**License # 45-09207-01**  
**Docket # 03003333**  
**Control No. 137935**

**Re: Request for Additional Information for License Renewal**

Lewis-Gale Medical Center Request for Additional Information  
14 Mach 2006 USNRC License #45-09207-01 Control #137935 Docket 03003333  
Ver 1.1

Lewis-Gale Medical Center  
License Renewal

6th Floor Layout:  
Layout of patient holding area  
where patients who cannot be  
released under 35.75 will be  
sequestered

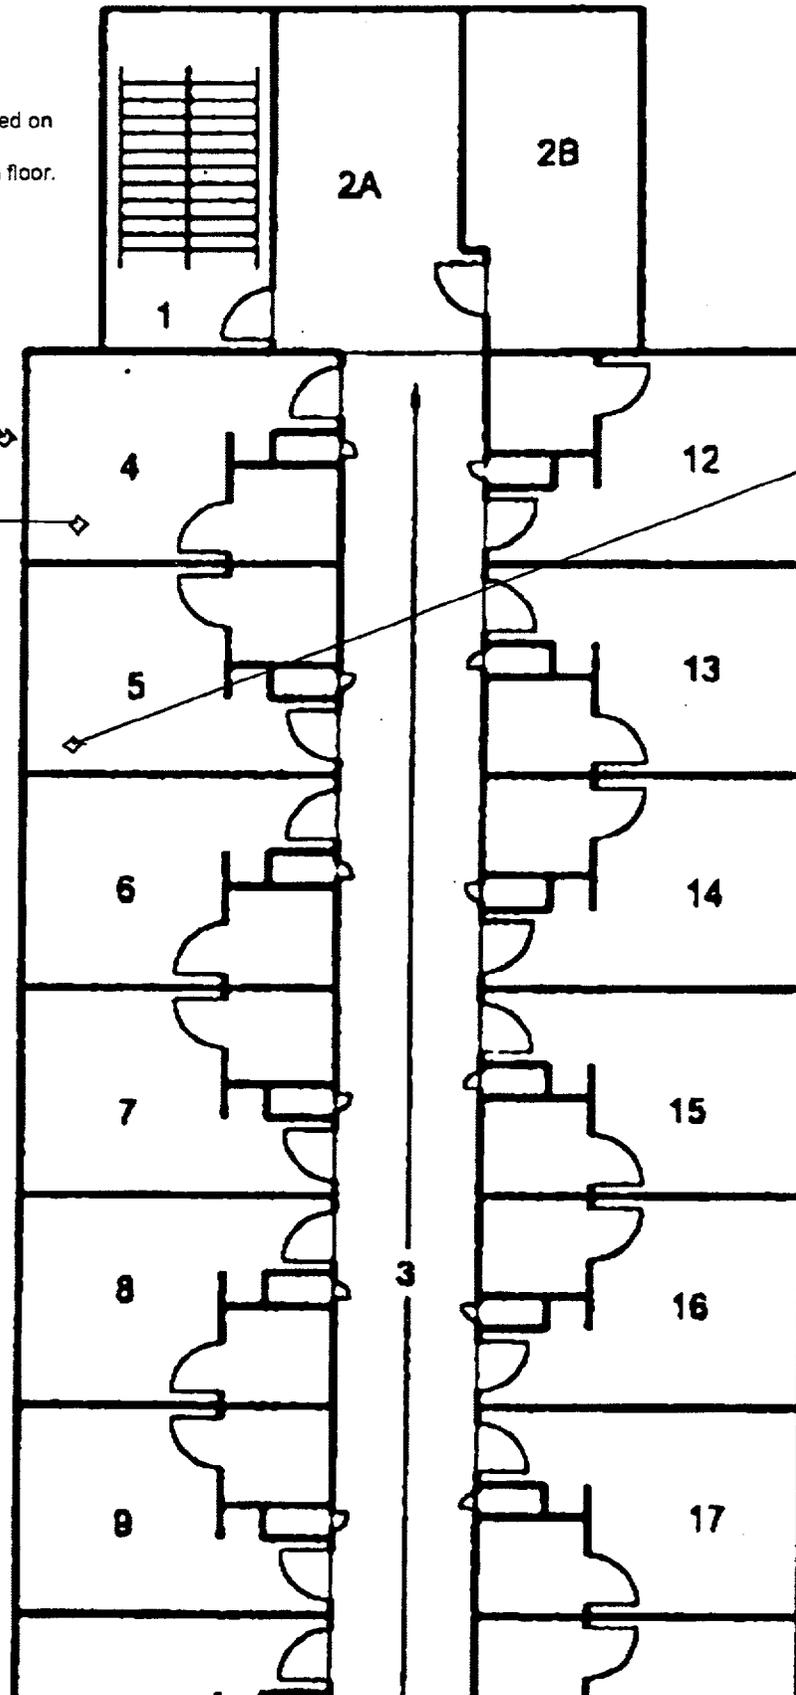
1. I have attached a new floor layout for the 6<sup>th</sup> floor where the patients undergoing Cs-137 low dose Brachytherapy are sequestered. Both of the test boxes were intended to point to room 664. I have moved the text box on the floor plan to indicate this.
2. Please find attached USNRC form 313A for Mr. James P. Nunn, MS to be added to our license application.

Room 664 is located on  
the exterior of the  
hospital on the 6th floor.

Room 664 is reserved  
for patients undergoing  
Low Dose Rate  
Brachytherapy.

Any Patients in Room 665 have  
their head positioned adjacent  
to room 666 to minimize  
unnecessary exposure.
